Crystal River Nuclear Plant
Docket No. 50-302
Operating License No. DPR-72

Subject: Crystal River Unit 3 – Response to "Crystal River Nuclear Plant, Unit 3 - Request for Additional Information, Regarding Response to Generic Letter 2004-02 (TAC NO. MC4678)"

RESPONSE TO REQUEST FOR ADDITIONAL INFORMATION REGARDING RESPONSE TO GENERIC LETTER 2004-02

A model of the test assembly for Test #1, showing the 3 x 3 strainer array surrounded by walls on all four sides, is shown below. Test #2 used a similar arrangement, but with a 3 x 2 top hat strainer array.

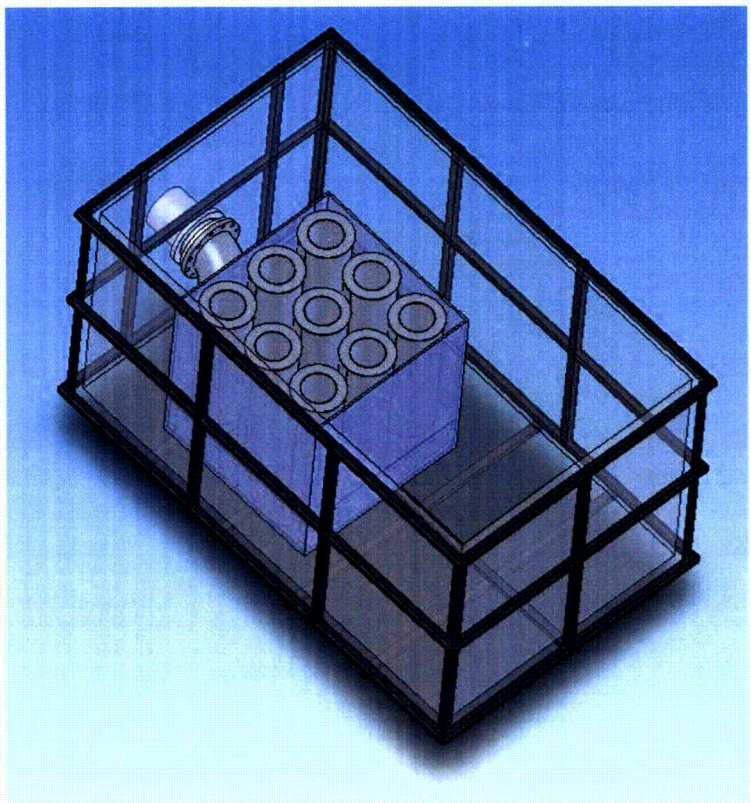
RAI #4 Please verify that the stirring used to prevent debris settlement did not non-prototypically affect bed formation.

Chemical Effects Testing for the CR-3 strainers was performed at the Alion test facility in Warrenville, IL, and monitored by Progress Energy personnel. The test utilized an approximately 6 feet tall by 6 feet wide by 10 foot long tank with a prototypical "top hat" strainer array. The strainer assembly was surrounded on all sides by panels designed to simulate sump pit walls (similar to the sump pit in the CR-3 reactor building). Pump suction was from the base of the sump, and the water was returned to the tank through a sparger located at the bottom of the tank along the back wall.

The sparger served to maintain the debris in suspension so that it could be transported to the sump pit and strainers. In addition, stirring was manually accomplished by slowly skimming the broad end of an oar across the bottom of the tank to lift any debris that may have settled, allowing it to be entrained in the current and transported to the sump pit.

The walls of the sump pit provided a physical boundary between the strainer array and the turbulence caused by the sparger and the oar. Therefore, the stirring did not non-prototypically affect the debris bed formation.
